REVISION 002
dated Apr 01/24

SERVICE BULLETIN

Information Regarding Screw Inspection for the

with PNR 1111475 Series Rotary Buckles

Figure 1
PNR 1111475 Series Rotary Buckle and Broken Screw Head

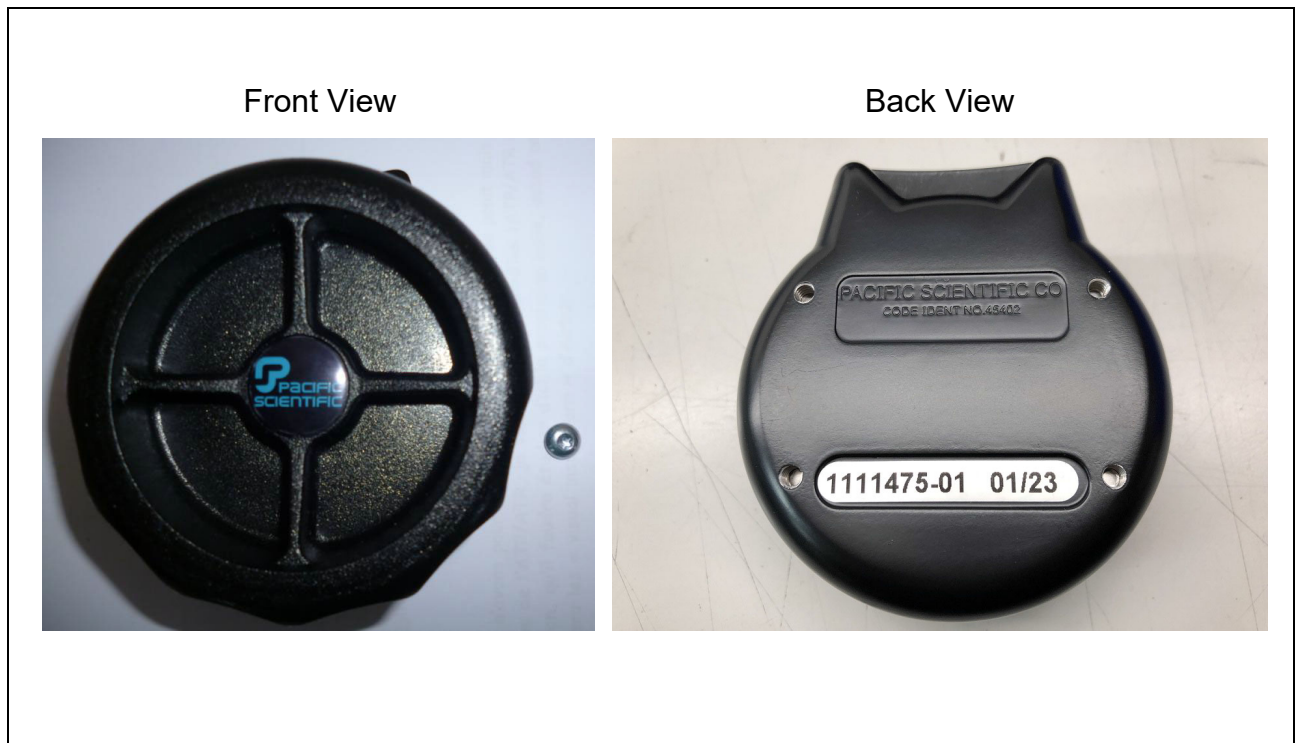
- (1) In 2012 a specific lot of PNR 0901101-123 screws were improperly zinc chromate plated. This manufacturing issue resulted in the screws becoming brittle. Evidence has shown that the screw heads can break-off under load creating an unsafe condition and improper function of the rotary buckle used on the restraint system.
- (2) Screws (PNR 0901101-123) used on rotary buckles (PNR 1111475 Series) are susceptible to premature failure of the screw.
- (3) Parker Meggitt has received field reports of cracked and missing screw heads. Figure 1 on page 7 shows an example of a PNR 1111475 Series buckle with a broken screw head.

This image is for reference only. In most cases, the broken screw head will be missing and not immediately obvious. Inspection per section 4.B. is required to determine whether a buckle has broken screws.

Figure 2
Flowchart of Required Operator Action

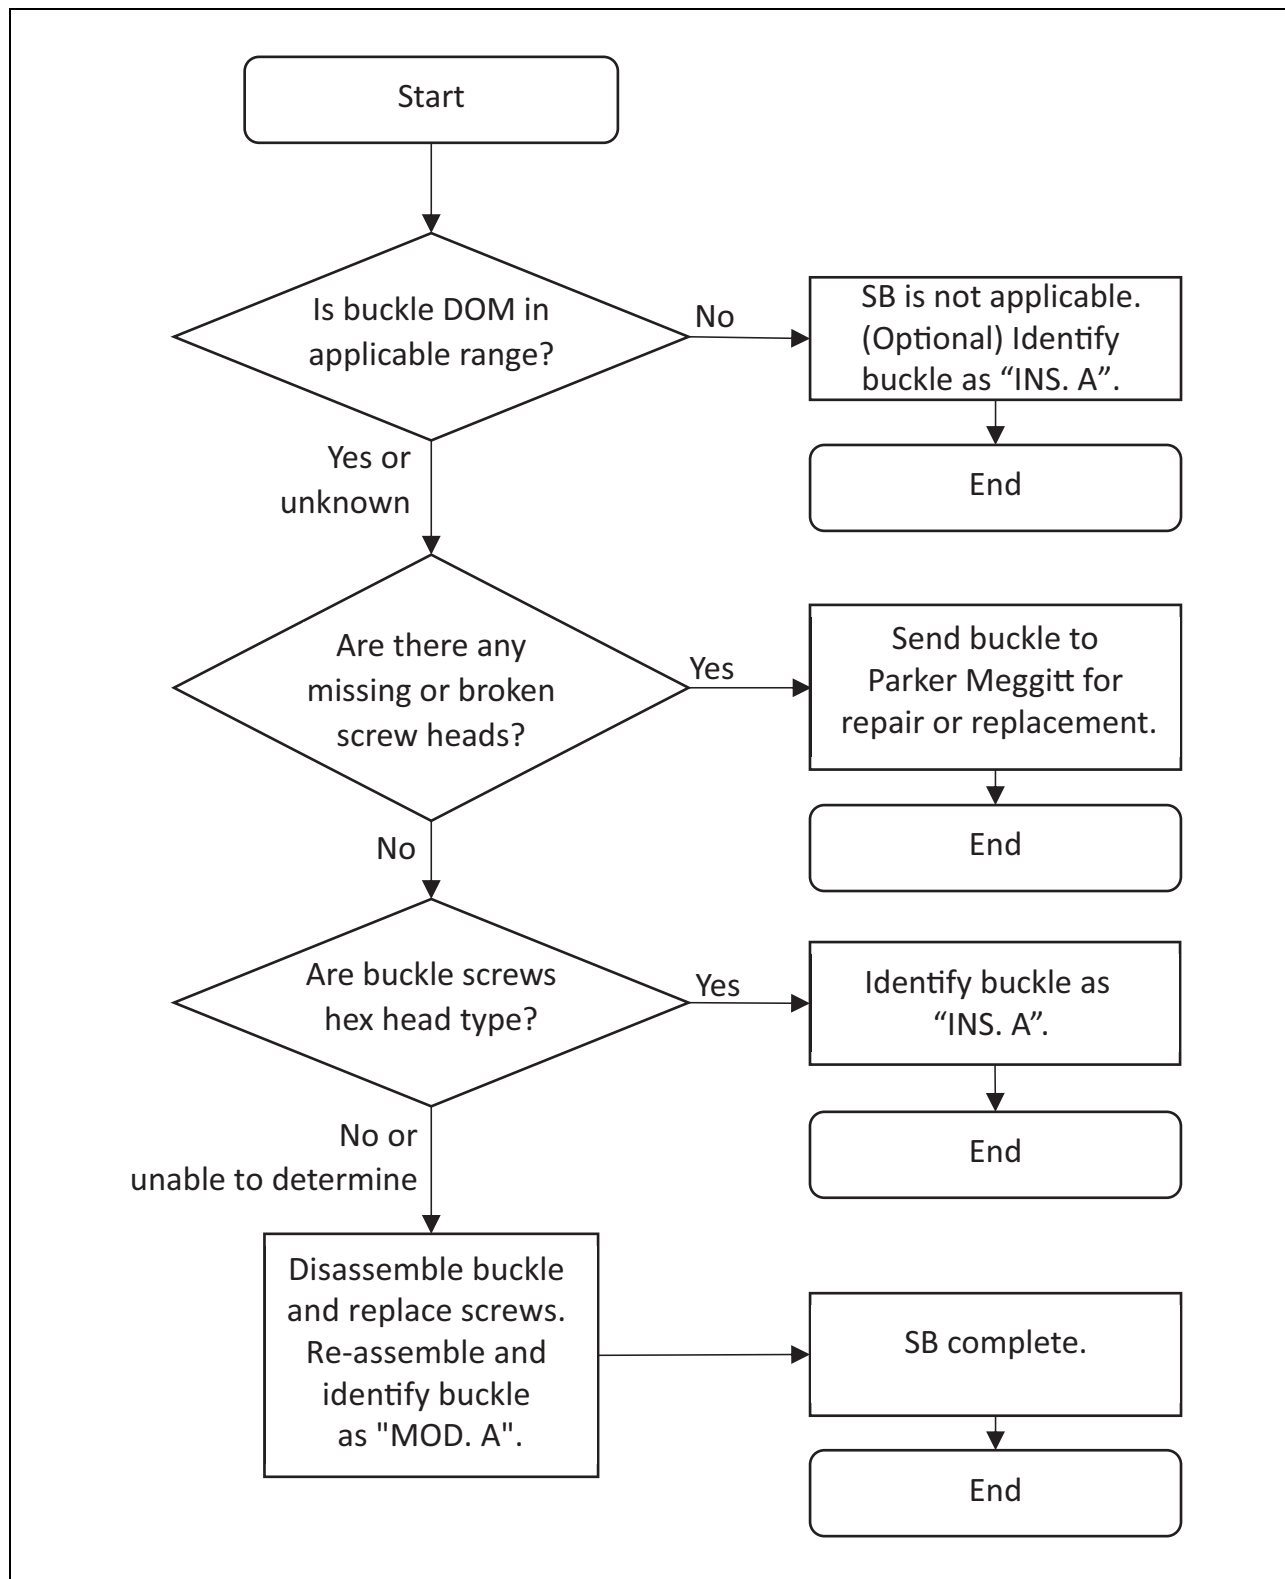
- (a) Refer to the flowchart in Figure 2 on page 10.
- (b) Operators should check all restraint systems and buckle assemblies in service and inventory that meet the criteria in sections 1.A. & 1.B. This also applies to restraint systems in storage or any restraint system that may have had a buckle replaced with one of these part numbers, or that may have been repaired using the suspect screws.

Figure 3
PNR 1111475 Series Rotary Buckle Screw Location

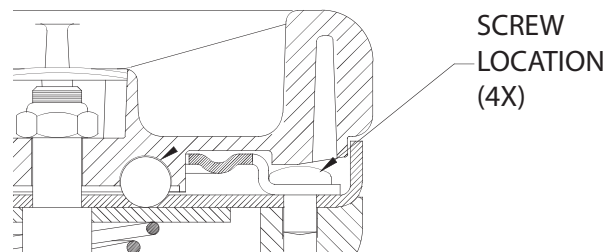
- (1) Use an inspection light to look through the belt openings in the rotary buckle. Refer to Figure 3 and Figure 4 on page 16 to locate the screws.
- (2) Inspect for the presence of 2 screw heads each on the left side and the right side of the buckle. Refer to Figure 5 on page 16.

Figure 5
PNR 1111475 Series Rotary Buckle Screw Head

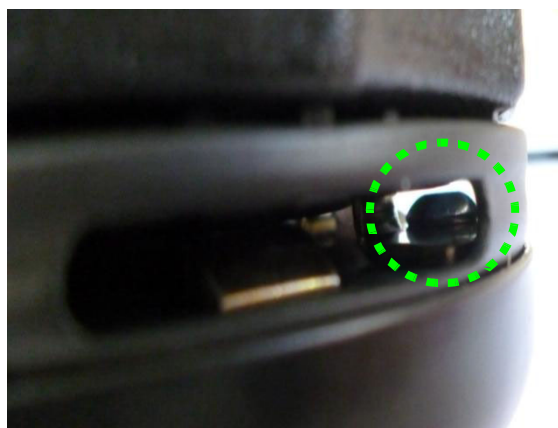
- (3) If any screw head is not present or is separated or not attached to the screw shank in the buckle :
- (a) Remove the buckle from service immediately. Refer to the procedure in section C. to remove the buckle from the restraint system.
 - (b) Replace the buckle with a new item. Refer to the procedure in section E. to install the new buckle in the restraint system.
 - (c) Send the damaged buckle back to Parker Meggitt for repair. Refer to section F. for contact information.
- (4) If the screw heads are intact, do one of the three following methods to determine if the screws are Torx head (alloy steel) or hex head (stainless steel) screws :

Figure 6
Magnet Test on PNR 1111475 Series Rotary Buckle with Velcro

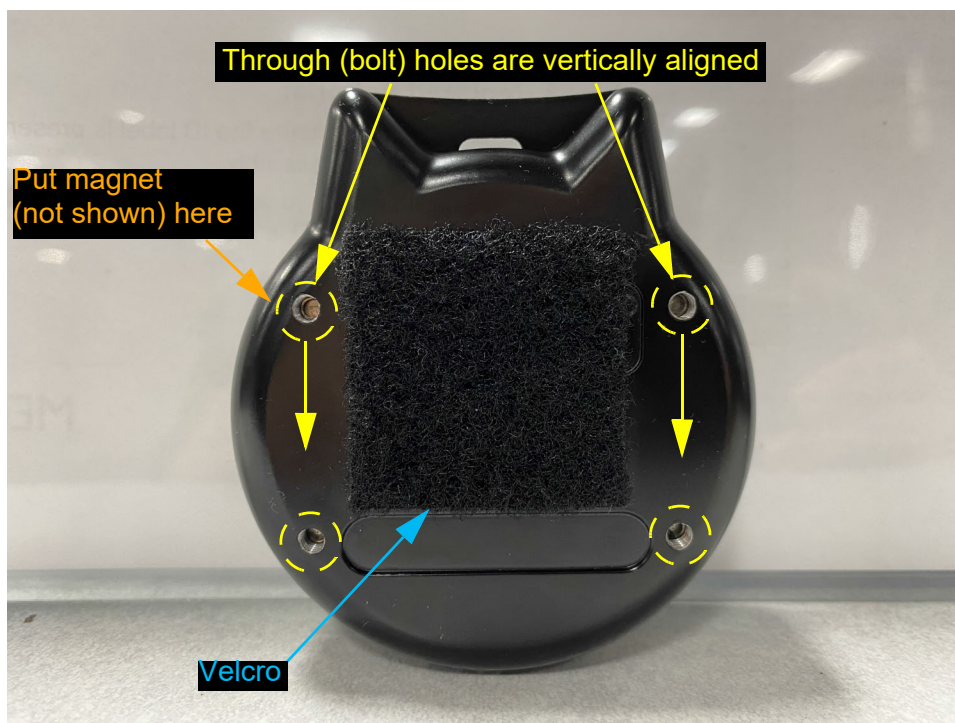
- b If the rotary buckle does have Velcro attached as shown in Figure 6 on page 18, hold the rotary buckle such that the through (bolt) holes align vertically, one directly above the other.

- 3 Put a magnet against the buckle back in the circled yellow area in Figure 6 on page 18 or Figure 7 on page 18 and release the magnet.
- 4 Repeat 2 and 3 for the other 3 through (bolt) holes.

Figure 7
Magnet Test on PNR 1111475 Series Rotary Buckle

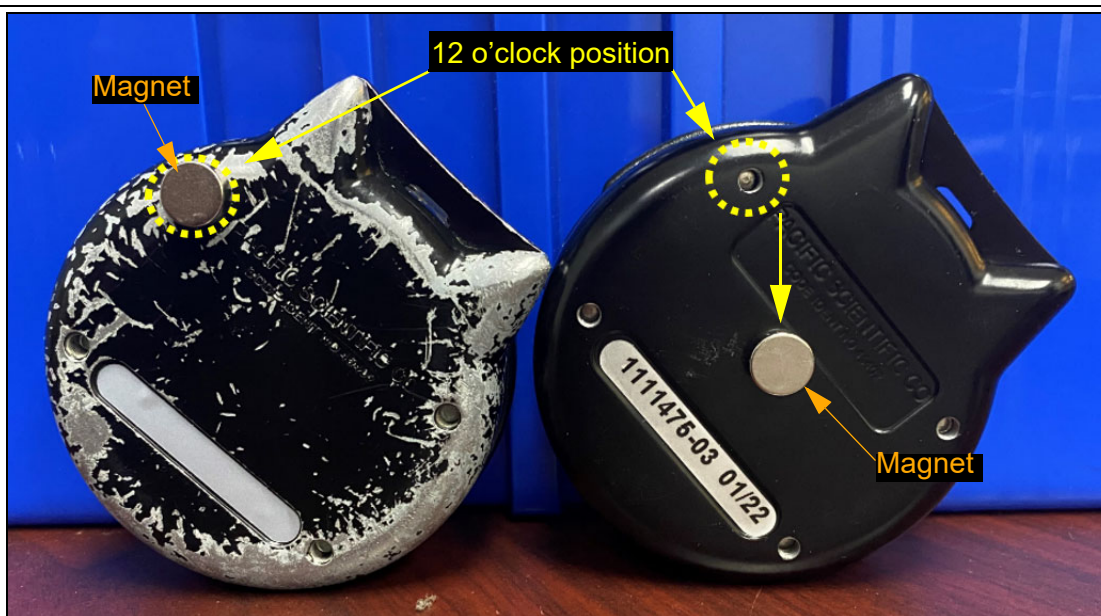
- 5 Interpret results for each of the following :
 - a If the magnet stays in place over the through (bolt) hole, this shows that the buckle has the Torx head (alloy steel) screws installed. The buckle WILL need the screws replaced. An example of this is shown in the left image of Figure 7 on page 18.

- b If the magnet slips down to and stops at the center of the buckle, this shows that the buckle has the hex head (stainless steel) screws. The buckle will NOT need the screw replaced. An example of this is shown in the right image of Figure 7 on page 18.

Figure 11
Removal of Rotary Buckle

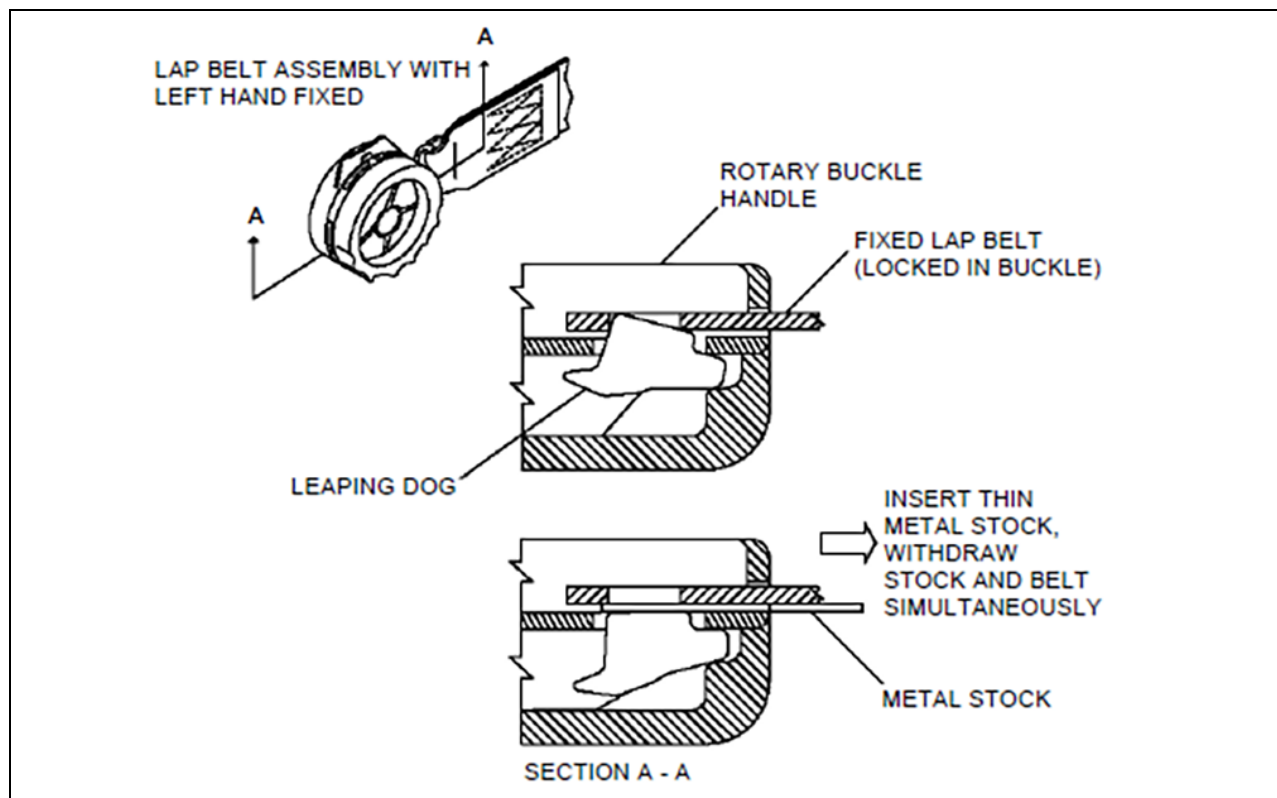
- (2) Refer to Figure 11.
- (3) Insert a piece of thin metal stock or shim into the slot of the rotary buckle and push inward between the fitting and the buckle locking mechanism.
- (4) Pull the fitting from the buckle.
